GENERAL APPLICATION

Location Address: 5730 JOHNSON STREET, HOLLYWOOD, FLORIDA

QUADS PLAZA
PROP. 2 STORY MULTIFUSE BUILD.
AT
5730 JOHNSON STREET
HOLLYWOOD, FLORIDA

PROPOSED SITE PLAN
SCALE: 3/32" = 1'-0"

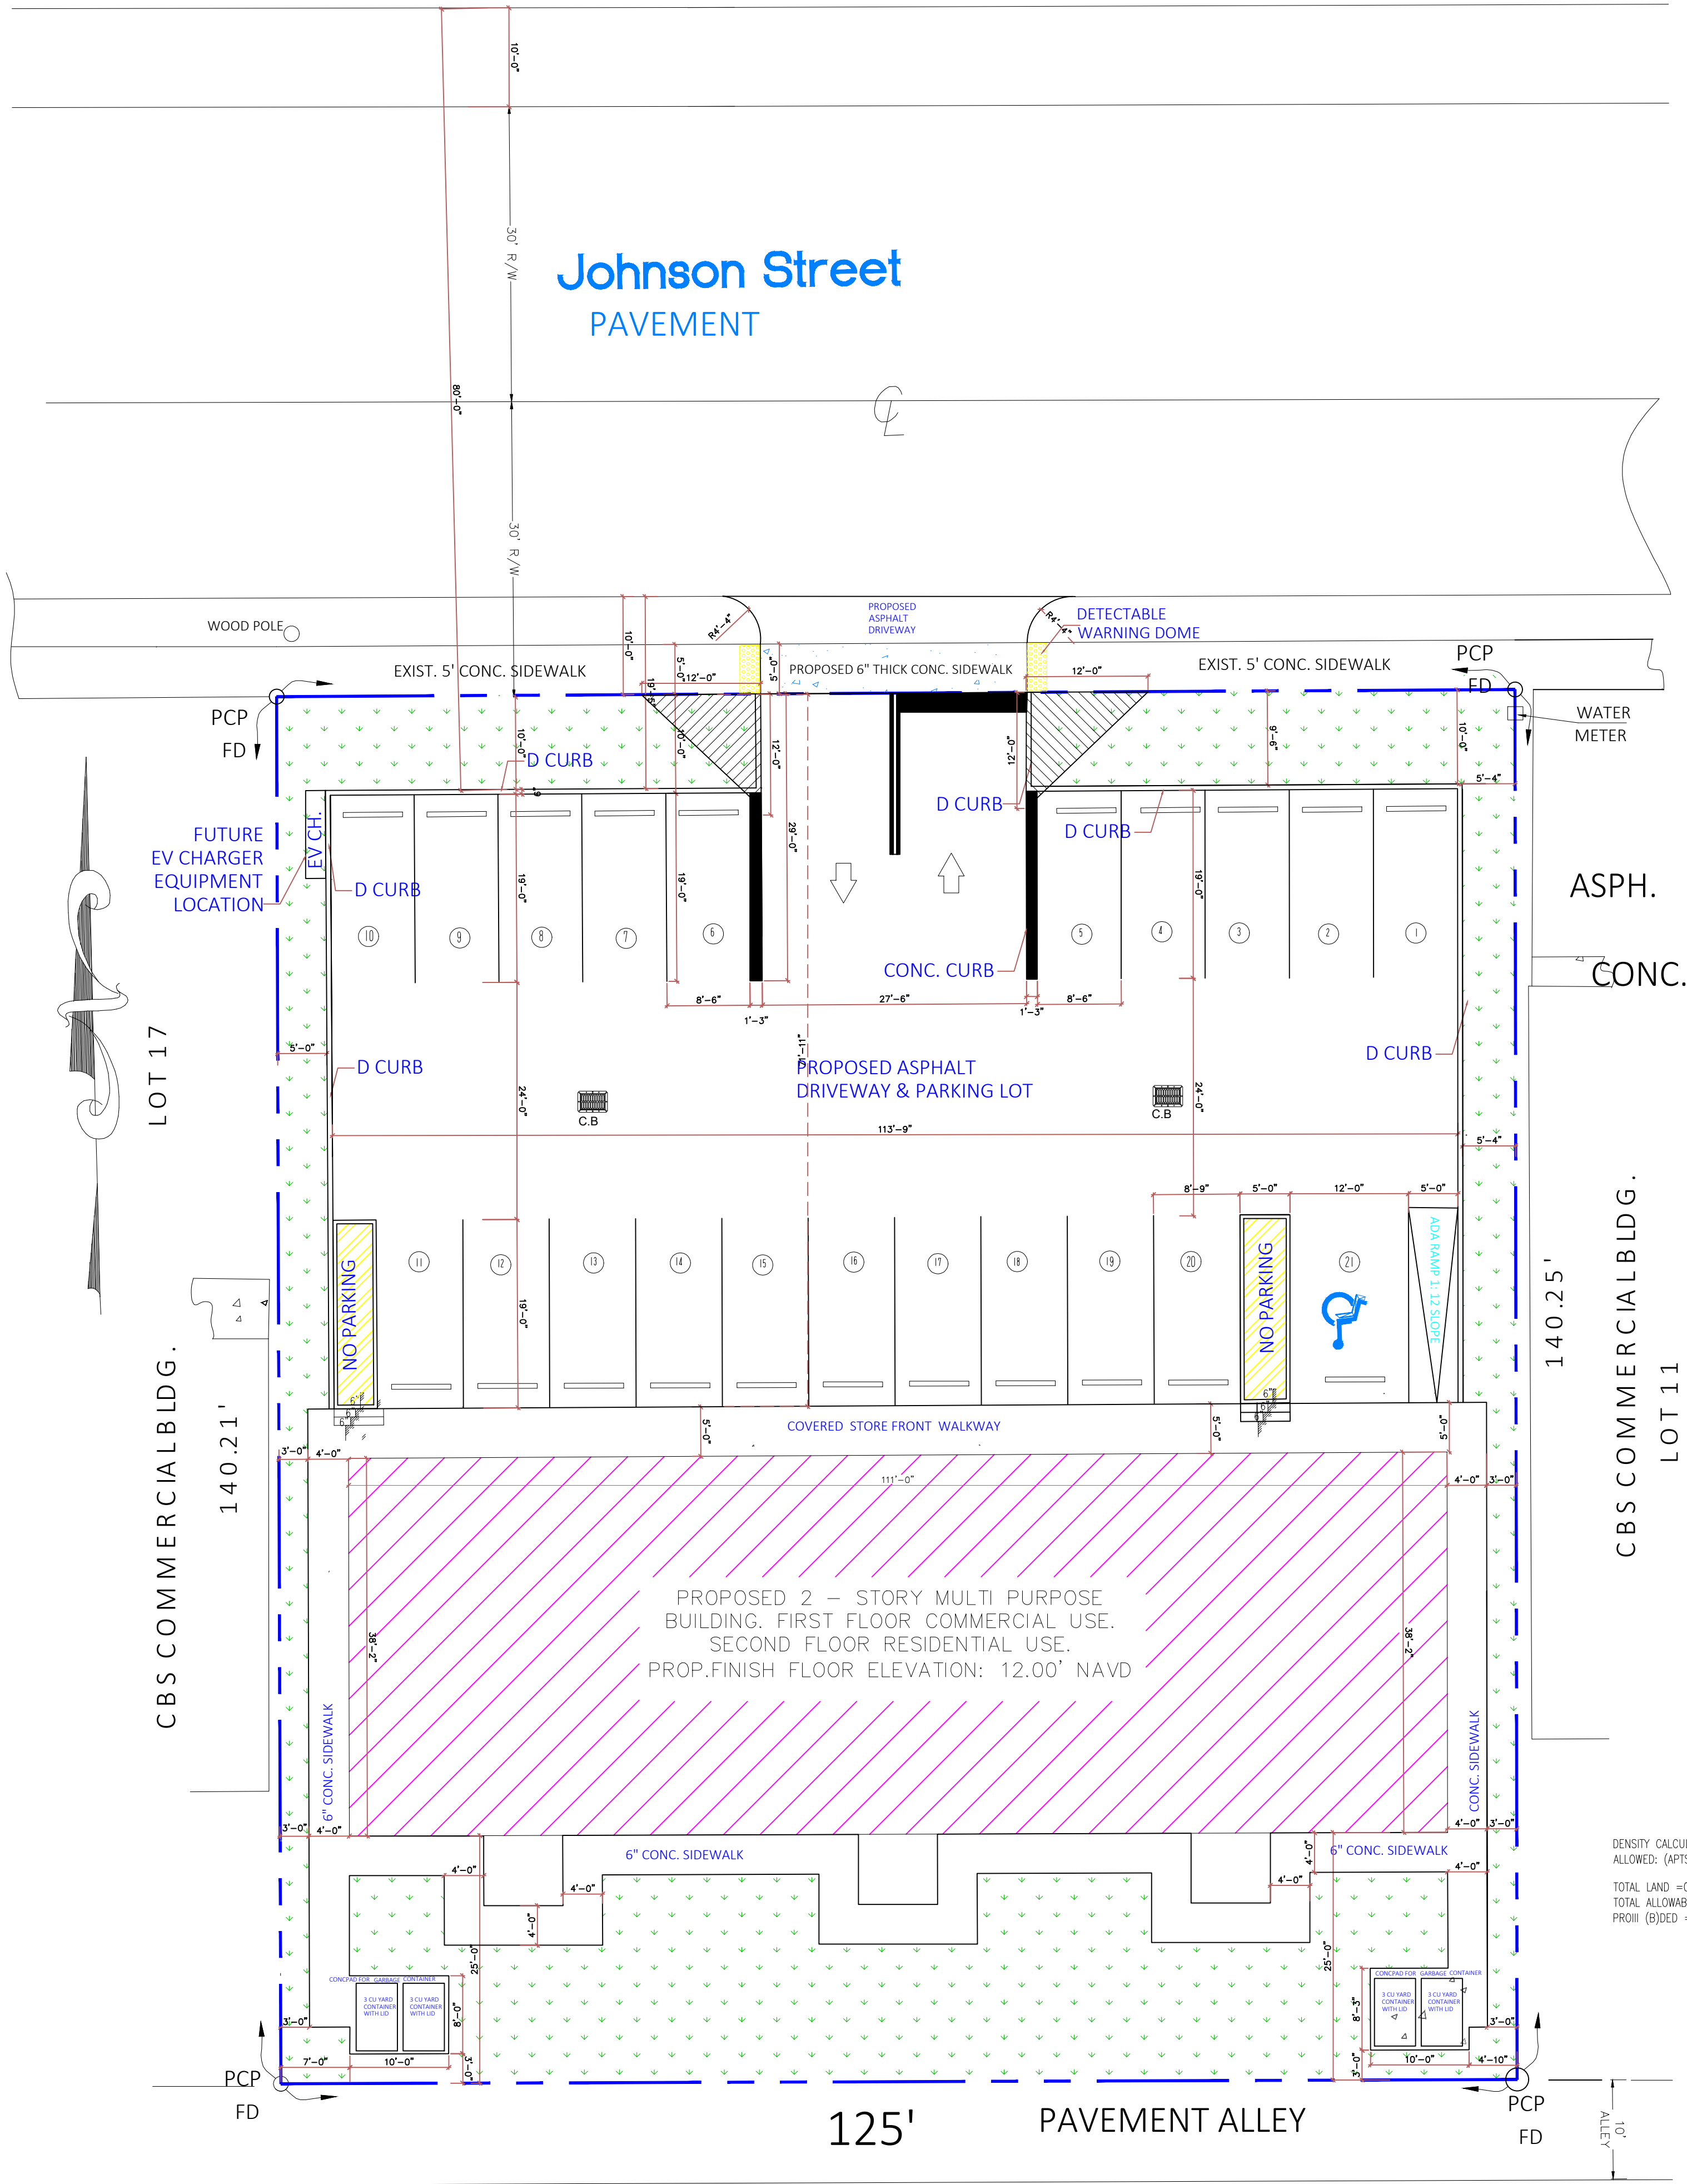
4. Site Plan:
 - a. Better emphasize the property line. Should carry a heavier line weight for easier distinction.
Response: The property line thickness has increase for better distinction. Please see the revised Site Plan SP-1.

- c. Show sight triangles and dimensions.

- d. Concrete pad/slab should be setback a minimum of 3'. Show setbacks on site plan.

- e. Concrete sidewalk shall be setback a minimum of 3'. Show setbacks on site plan.

- f. Show walkway setbacks and dimensions. Walkways shall be setback a minimum of 3' from the property line.

- m. Provide VUA calculation on site plan. Shall not include the required 5' landscape buffer.

10. On Sheet SP-1, Applicant shows two (1'-3" and 1'-1" wide) strips parallel to the entrance/exit driveway. Please clarify what these are, identify material and if they are raised and above ground features. Provide height and any applicable details as needed.

26. Alley is misspelled on the Site Plan.

9. Sheet SP-1 indicates FFE = 12.00' NAVD88 and Sheet A-3 indicates the finished floor at 11.25' NGVD29. Ensure all elevations reference NAVD88.

Response: Please see the sight triangle on the revised site plan SP-1.

Response: Please see the 3' setback for the concrete pads on the revised site plan SP-1.

Response: Please see the 3' setback for the concrete sidewalks on the revised site plan SP-1.

Response: Please see the 3' setback for the concrete sidewalks/walkways on the revised site plan SP-1.

Response: VUA calculation is shown on the revised site plan. Please see the sheet SP-1.

Response: Both of the 6" raised traffic separator concrete curb to be 1'-3" in wide and 6" above the ground. The curb details will be provide on the civil plan during construction permit.

Response: The spelling is corrected.

Response: Proposed building's finished floor elevation is 12.0' NAVD. Please see the revised elevation on the sheet A-3.

DATE: 09/10/2022
DRAWN BY DM
PROJECT NO. 2022-00129
REVISED BY MN
SHEET NO. A-1

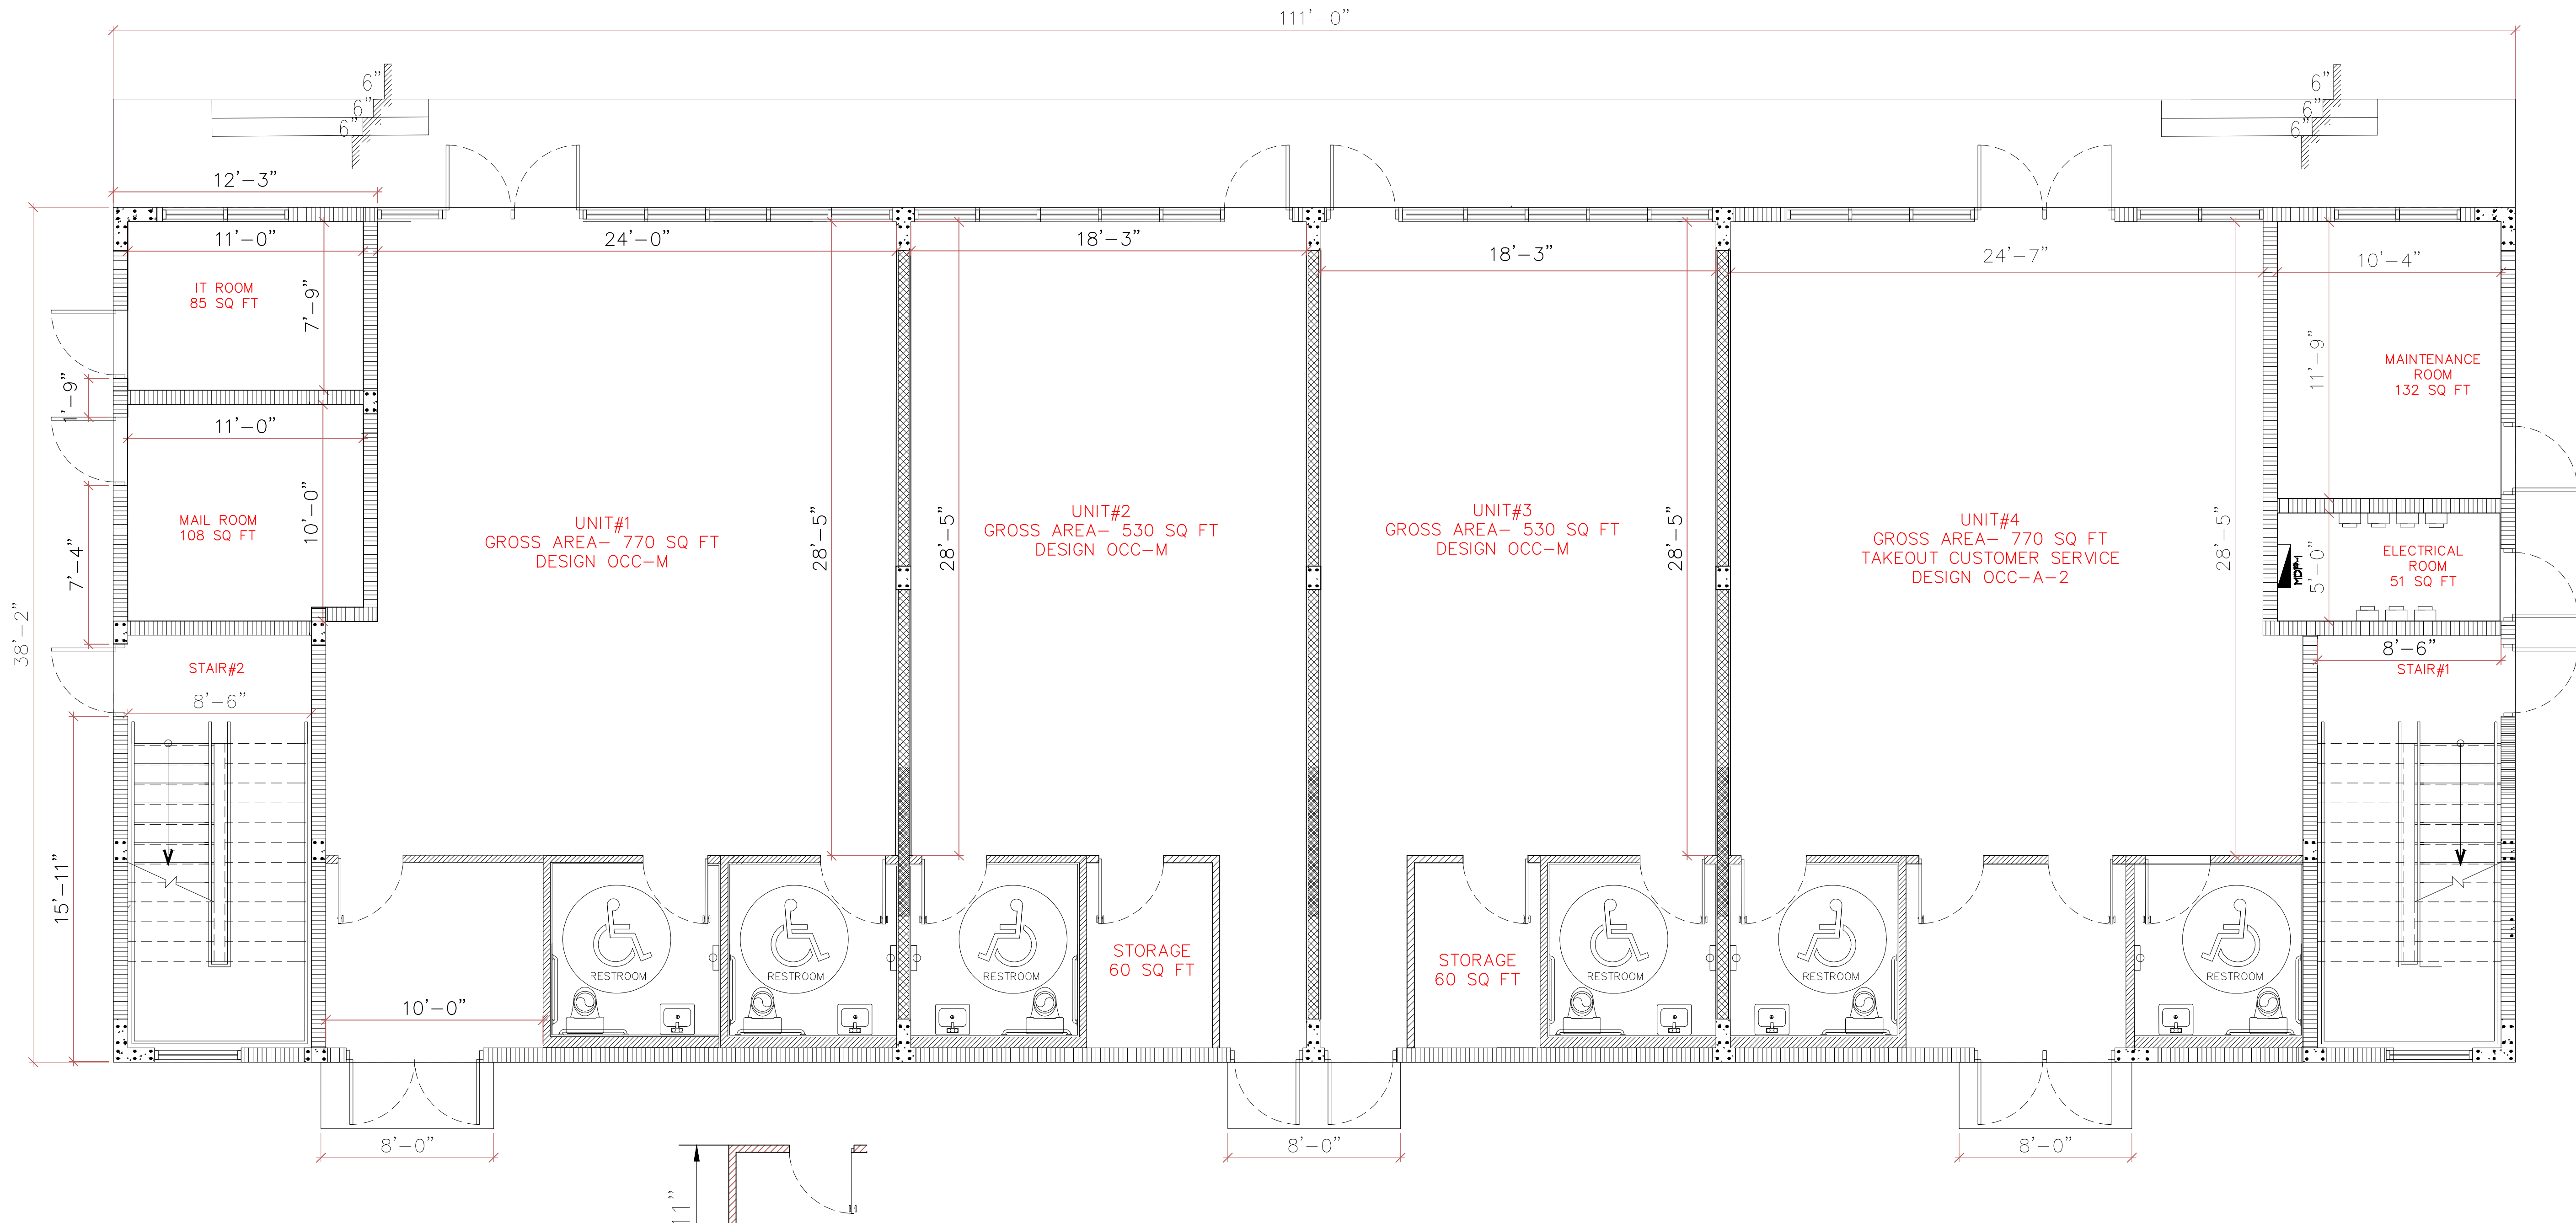
- j. Make door entry way for commercial unit #1 consistent with commercial unit #4. Show consistency on elevations sheet.

4. There is a discrepancy with regard to the construction type proposed. --- Page A-1 states "VI" while page SP-1 states "III (B)." --- Clarify and correct on the plans.

Response: unit#1's door has match with the unit#4's door. Please see the revised floor plan A-1 and elevation on the sheet A-3.

Response: Sheet A-1 is corrected.
